REPORT AMENDED BY CPC & STAFF 2-9-89  
**CITY PLANNING COMMISSION**

- A. Negative Declaration
- B. Rezone 5.45+ vacant acres from Single Family Alternative (R-1A) to Multi-Family (R-2B) zone.

**LOCATION:** Northwest corner Norwood and Bell Avenue

APPLC. NO. P88-371 MEETING DATE 2-9-89 January 26, 1989 ITEM NO. 6  
13

**EXHIBIT A  
SITE PLAN**

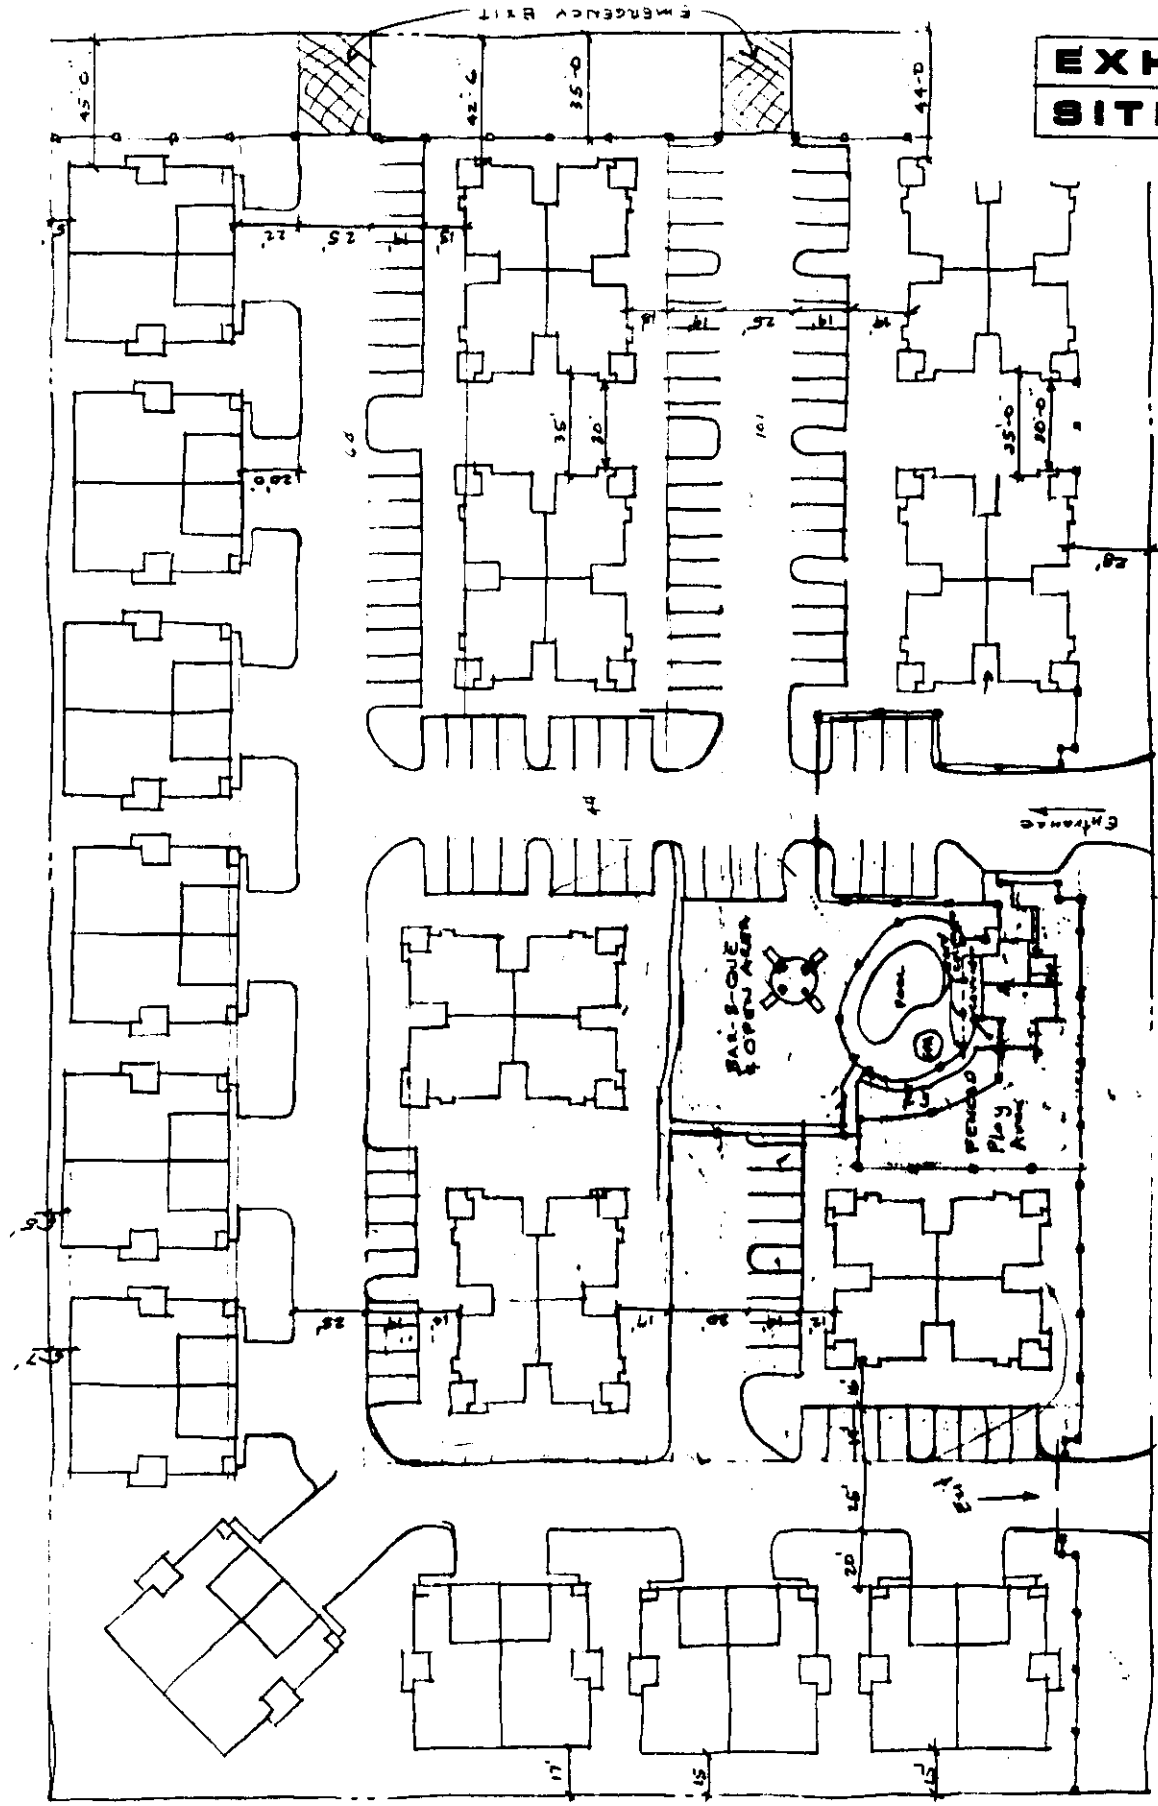
The submitted site plan indicates the proposed duplexes on the north and west perimeter of the subject site and apartments on the interior and south perimeter (see site plan). The recreation building and open outdoor area fronts on Bell Avenue. The site plan shows a fence along Bell and Norwood Avenue. The applicant indicated to staff that the fence will be made of wrought iron material with a security gate fronting on Bell Avenue and two emergency exits fronting on Norwood Avenue. A six foot, wooden fence exist along the north and west property lines separating single family residences from the subject site. Staff recommends that a six foot high, wrought iron fence be placed along the east and south property lines.

Currently, there are no trash enclosure locations indicated on the site plan. Staff recommends that at least three trash enclosure locations be identified on a revised site plan to be reviewed and approved by the Planning Director. Trash enclosures shall comply with Zoning Ordinance requirements.

A total of eighty-eight (88) parking spaces are required for the apartments based on the 1.5 to 1 parking ratio and an additional one guest space per every 15 unit parking requirement. The applicant is proposing 110 parking spaces which includes eight spaces outside of the security gate on the subject site. In reviewing the site plan, it appears that the back out maneuvering space is less than the required 26 feet. The site plan indicates 25 feet. Staff recommends that the site plan be modified to reflect the 26 foot of maneuvering space to allow cars to back out in a sufficient amount of space. The applicant is proposing two car garages for each duplex. Staff has no objections to this proposal.

The applicant is also discouraging parking on the street by installing a security fence on the interior property line and providing eight spaces outside of the enclosed gate. Staff recommends that the projects parking area comply with the 50 percent shading of surfaced areas required by the Zoning Ordinance.

No landscaping and irrigation plans were submitted for staff review and approval. Staff recommends that a minimum 25 foot landscape setback be provided along Norwood Avenue and Bell Avenue. The landscape setback shall consist of lawn material with three and one-half foot undulating berms and trees along Norwood and Bell Avenue. No landscaping is indicated on the site plan along the perimeter or within the project area.

The site plan does not indicate proposed signage on the subject property. All new signage must comply with the Sign Ordinance Regulations and shall be submitted to staff for review and approval prior to issuance of sign permits. Signs for apartments require a Planning Director's Special Permit.

- a. Provide three foot flairs on driveways.
- b. Remove bubble shape from west driveway on Bell Avenue.
- c. Construct Norwood Avenue to an 80 foot right-of-way.
- d. Construct Bell Avenue to a modified 80 foot right-of-way.
- e. Provide an expanded intersection at Bell Avenue and Norwood Avenue to the satisfaction of the Traffic Engineer.

1. The applicant shall redesign the site plan to the satisfaction of the Planning Director prior to issuance of building permits. The revisions shall include increasing the width of the back out maneuvering space to 26 feet and indicating the three trash enclosure locations.
2. A six foot high wrought iron fence shall be placed along the east and south property lines.

11. The parking lot shall comply with the 50 percent shading of surfaced areas required by the Zoning Ordinance.
12. A minimum 25 foot landscape setback shall be provided along Norwood Avenue and Bell Avenue. The landscape setback shall consist of lawn material and shrubs with three and one-half foot undulating berm and trees along Norwood Avenue and Bell Avenue.

13. Landscaping and irrigation plans shall be submitted for review and approval by the Planning Director prior to issuance of building permits. The landscaping material shall consist of ground cover with one and five gallon shrubs and five and 15 gallon trees.

14. All new signage shall comply with the Sign Ordinance regulations.
15. Provide three foot flairs on all driveways.
16. Remove bubble shape from far west driveway on Bell Avenue.

Duplex Elevations

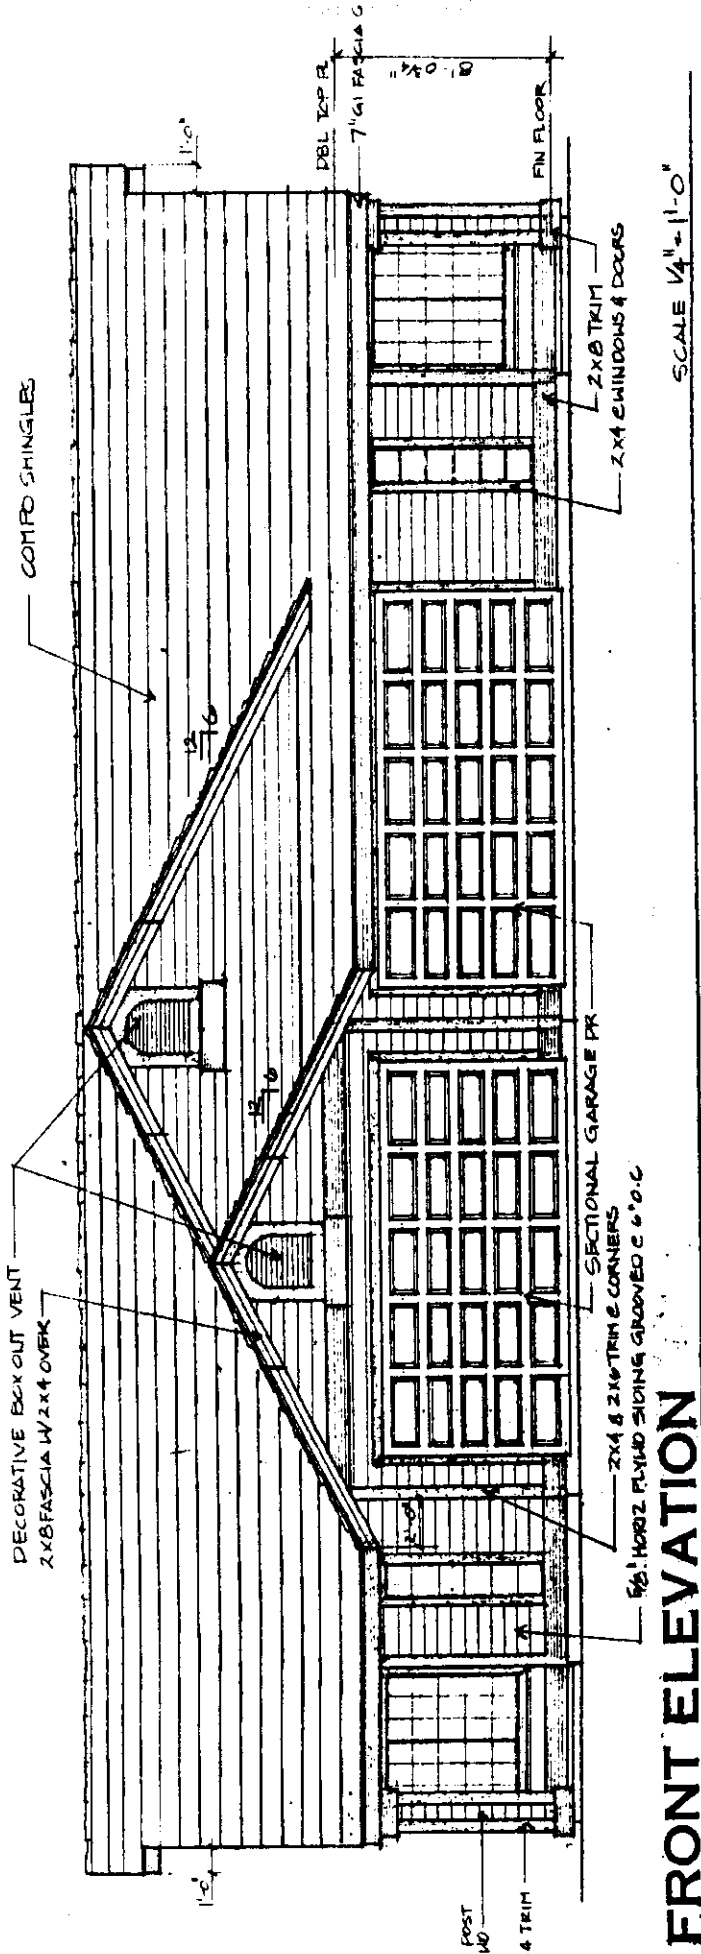
The building elevations for the development feature the use of horizontal plywood siding walls with grey and blue trim color. The roof material is made of composition shingles. Three bedrooms are proposed for the duplexes and two bedrooms are proposed for the apartment units. Planning staff and design review staff reviewed the proposed apartment, duplex and recreation structures and propose the following modifications:

3. The applicant shall provide six foot high wood fencing material between the duplexes to allow for privacy.
4. Building materials and coloring shall be reviewed and approved by the Planning Director. Each building shall have a body color and trim color and shall be two distinct colors.

5. Exterior building material shall be made of horizontal wood siding or horizontal masonite siding. The masonite shall be a heavy thickness on all buildings.

6. The applicant shall provide six foot high wood fencing material between the duplexes to allow for privacy.
7. Building materials and coloring shall be reviewed and approved by the Planning Director. Each building shall have a body color and trim color and shall be two distinct colors.

**Apartment/Elevations**

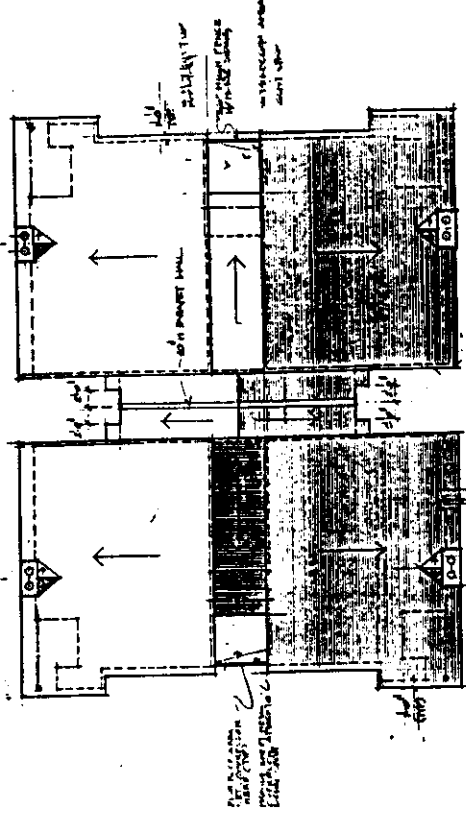
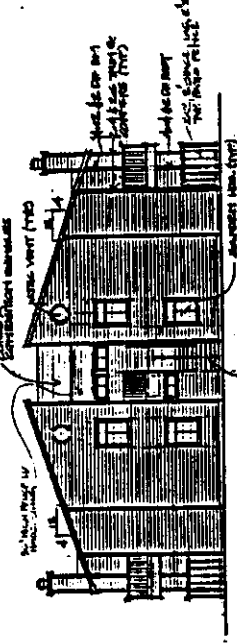
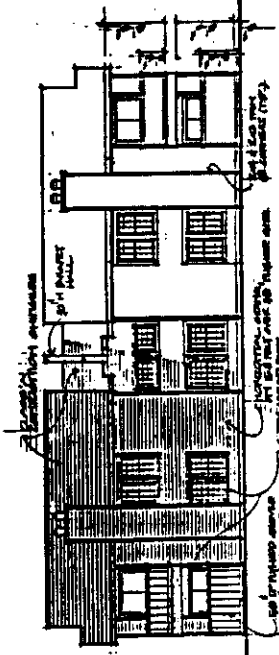
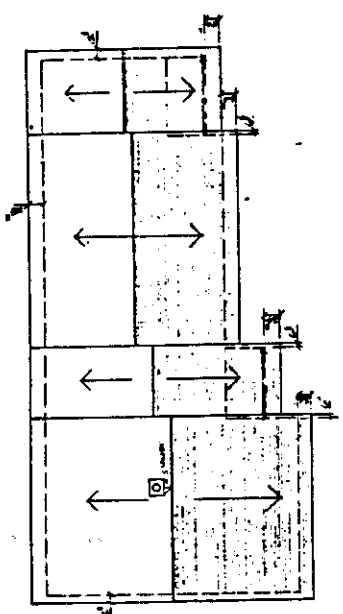
6. Patio fences and balcony railings shall be solid for privacy and to screen material stored on the interior from public view.
7. The proposed parapet wall on the apartment buildings shall be covered in a material to match all other exterior walls of the structure.

9. Patio fences and balcony railings shall be solid for privacy and to screen material stored on the interior from public view.
10. The proposed parapet wall on the apartment buildings shall be covered in a material to match all other exterior walls of the structure.
